FIELDHOUSE USA AT AURORA TOWN CENTER

SITE PLAN AMENDMENT

COVER SHEET

FIELDHOUSE USA AT AURORA TOWN CENTER
CITY OF AURORA
SITE PLAN AMENDMENT
LANDSCAPE PLAN (SE)

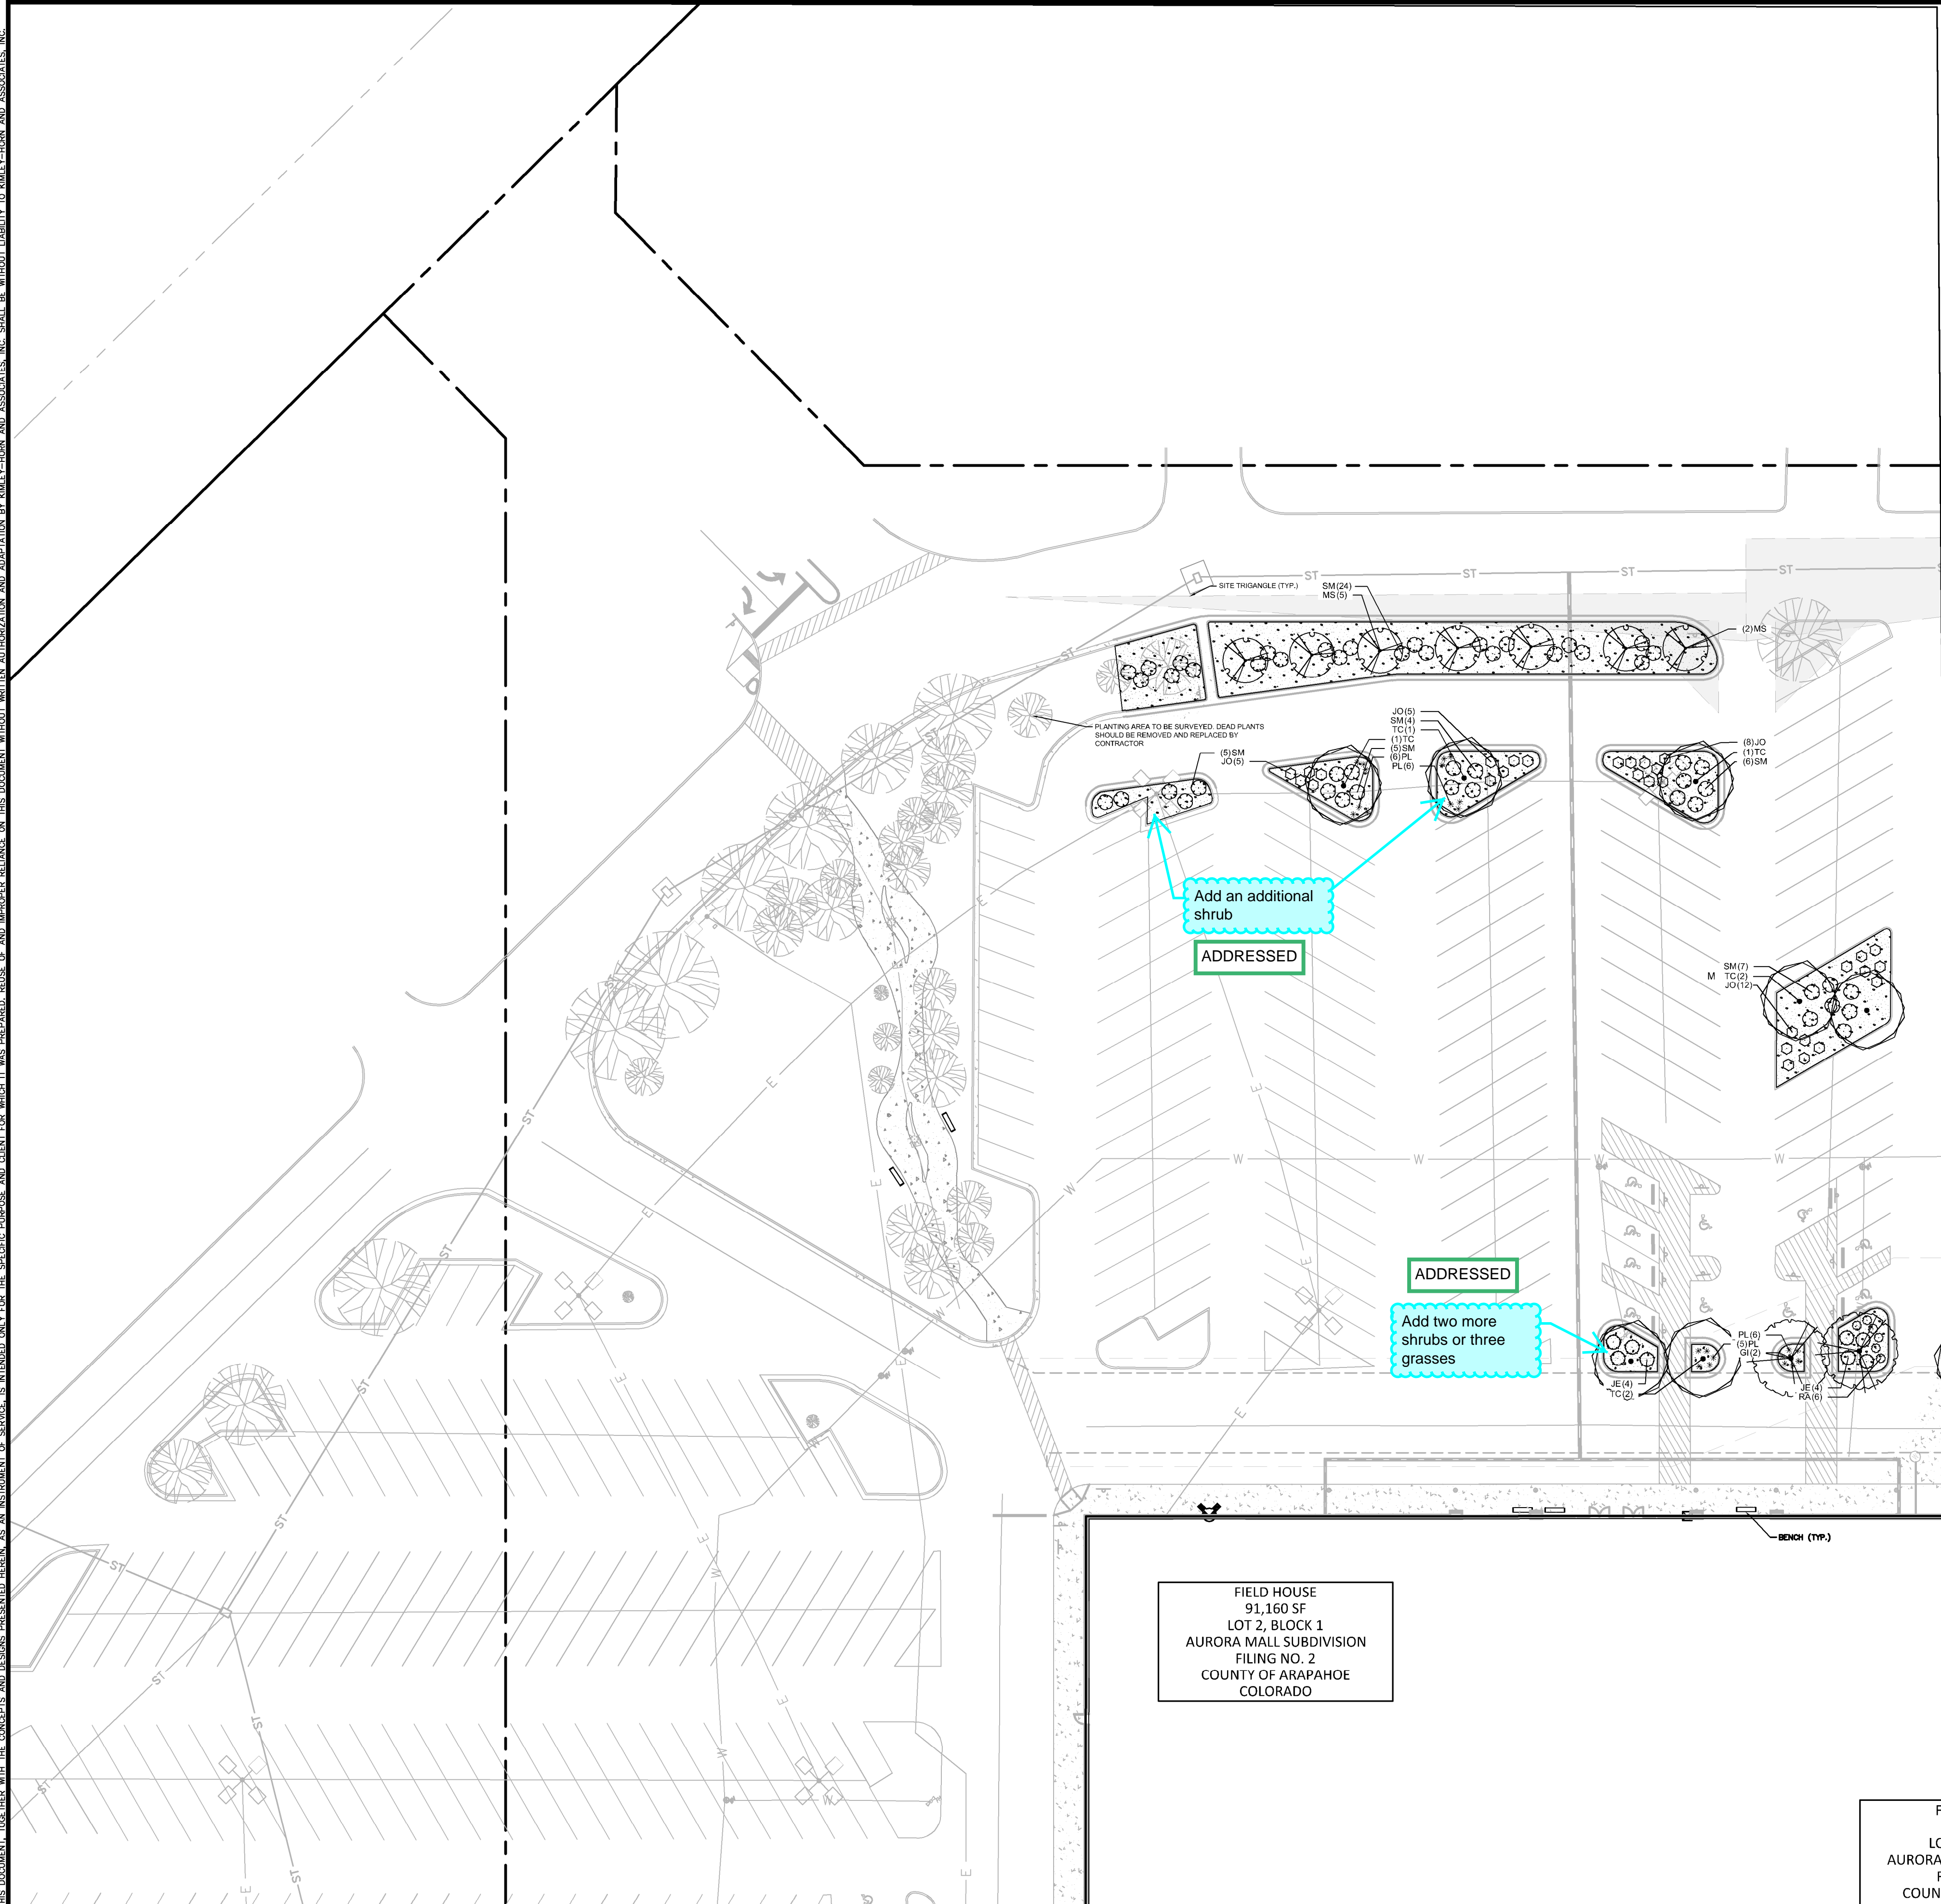
These are only 1 gallon. Three (1) gallon = 1 (5) gallon shrub. Therefore only 2.5 shrubs are being proposed not 6. Add more shrubs. Grasses are non-existent in the winter months. They are either cut back or impacted by snow loads.

Show sight triangles on this sheet for all access points exiting to ring road from parking lot (Per COA STD TE-13.1, 25mph Design speed)

Update the notes accordingly

ADDRESSED

ADDRESSED
